SALT WATER CORROSION on TRANSMISSION ELECTRIC SHIFT

(Attach Bulletin Reference Sticker to New P. 7C-24 of Your Service Manual.)

MCM 225-TR and 255-TR Stern Drive Engines
MCM II-TR (Serial No. 3640148 and Below) WITH Power Steering
MCM II-TR (Serial No. 352885 and Below) WITHOUT Power Steering
MCM 255 II-TR (Serial No. 3524331 and Below) WITH Power Steering
MCM 255 II-TR (Serial No. 3523800 and Below) WITHOUT Power Steering

**Figure 1. Nuts and
Cap Screw Locations**

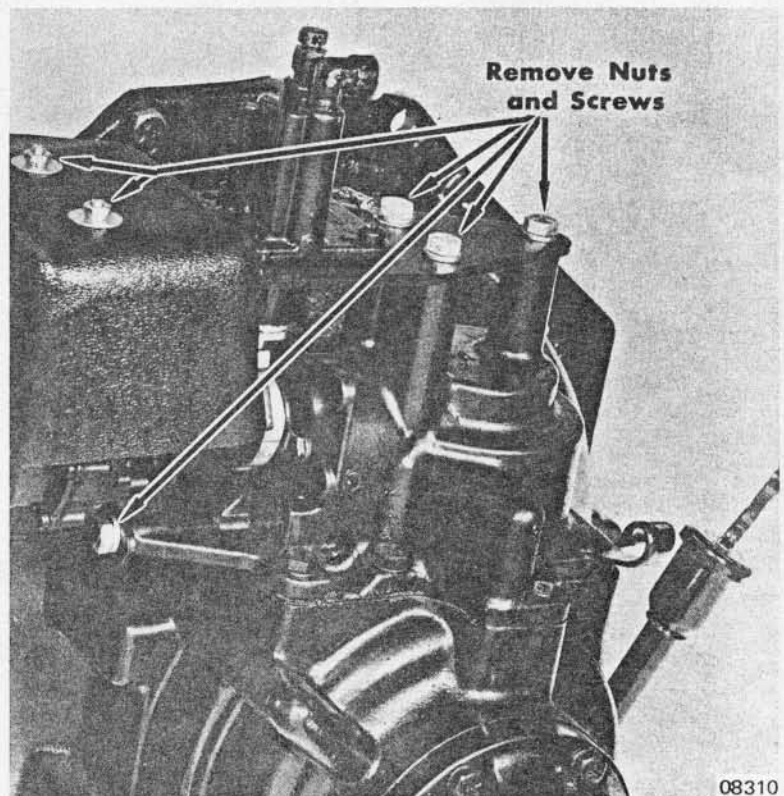
1. Disconnect the ground cable from the battery.
2. Remove the cap screws and nuts as shown in Figure 1.

Figure 2.
Lubricating
Components

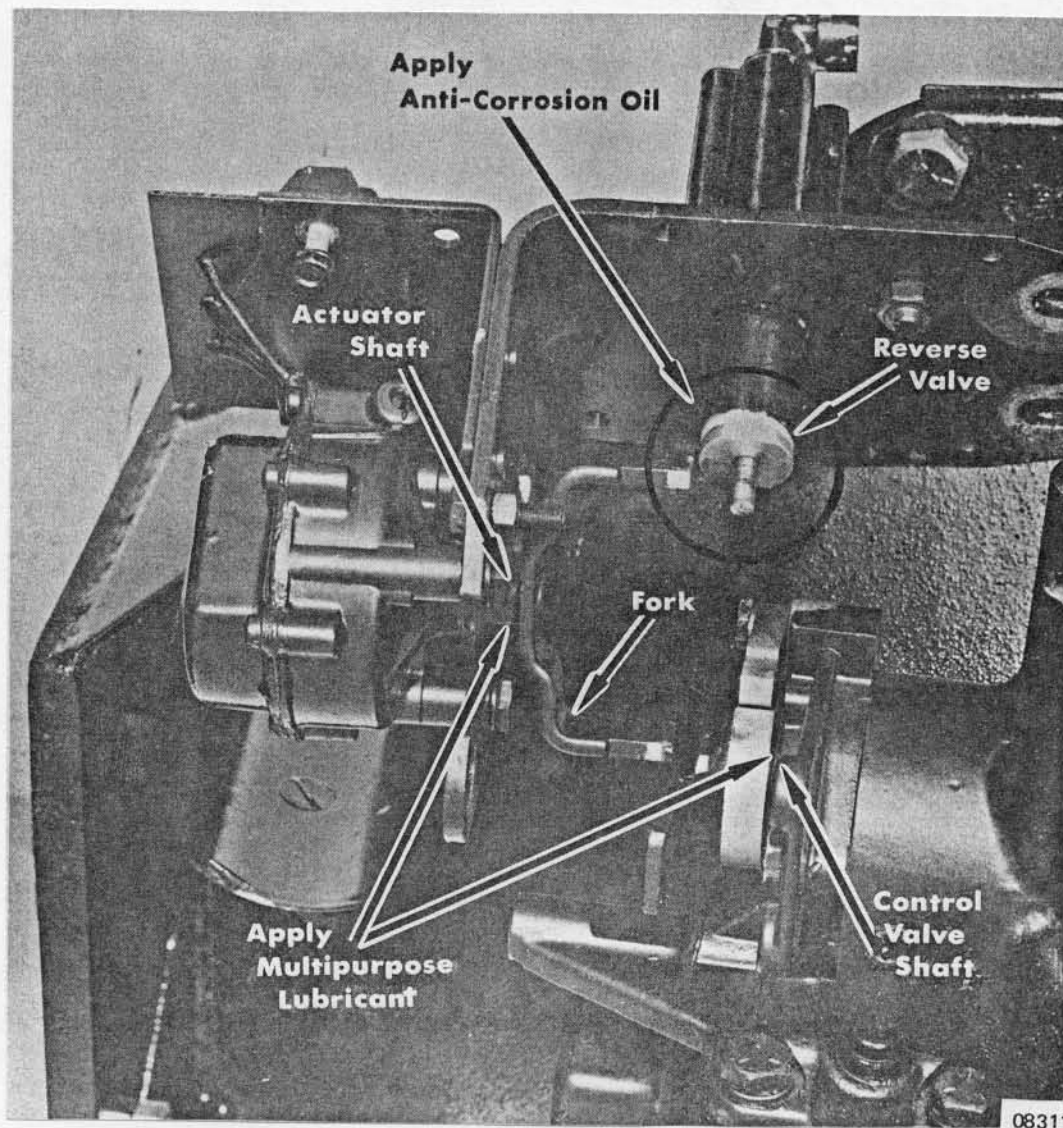
3. Tilt actuator and bracket forward as shown in Figure 2.
4. Clean salt deposits from plunger end of reverse lock assembly and apply a coat of Anti-Corrosion Oil (C-92-39928) on area shown in Figure 2.
5. Clean salt deposits from electric shift actuator shaft and from control valve shaft and apply a liberal amount of Multipurpose Lubricant (C-92-49588 or C-92-63250) to completely fill the space between end of motor housing and fork of output shaft. Also use Multipurpose Lubricant to fill the space between cam for reverse lock valve and cover on transmission, as shown in Figure 2.
6. Reassemble shift actuator assembly to transmission and replace actuator cover.
7. Connect ground battery cable and test unit for shifting to be certain that lubricated parts are working freely.
